Application Details	
Application Type	Development Permit – Material Change of Use
Defined Use	Special Industry (Whisky Distillery)
Street Address	25 Finchley St Milton
Client	Lynette Anne Lee, Michael Lee
Local Government Area	Brisbane City Council
Date	November 2019

**Material Change of Use-Special Industry (Whisky
Distillery) -
Noise Impact Assessment**

1.3 FURTHER BCC RFI – 9TH DECEMBER 2019

Proposed First Floor Plan
scale: 1:100 @A3
date:

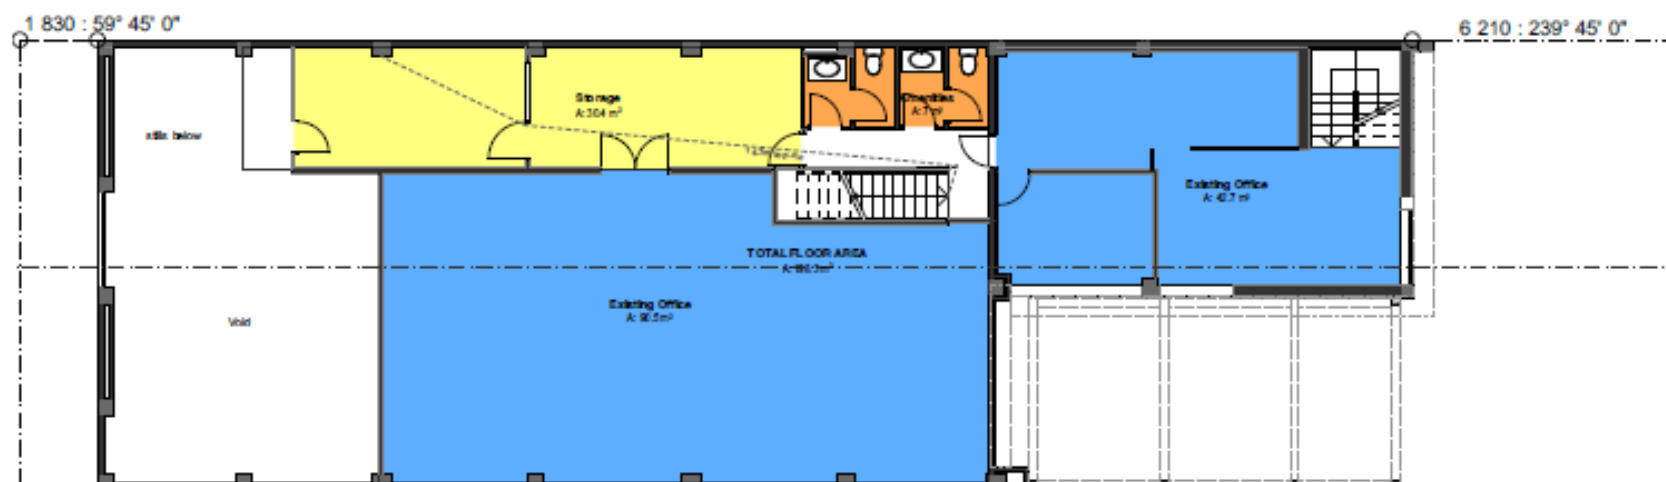
- Revised plan dated 8/11/19 now shows a new `external dining? area on ground floor plan, as well as new function areas.
 - **Response: The revised plans including external dining is not being considered at this stage. Refer to the response from Planning Initiatives.**
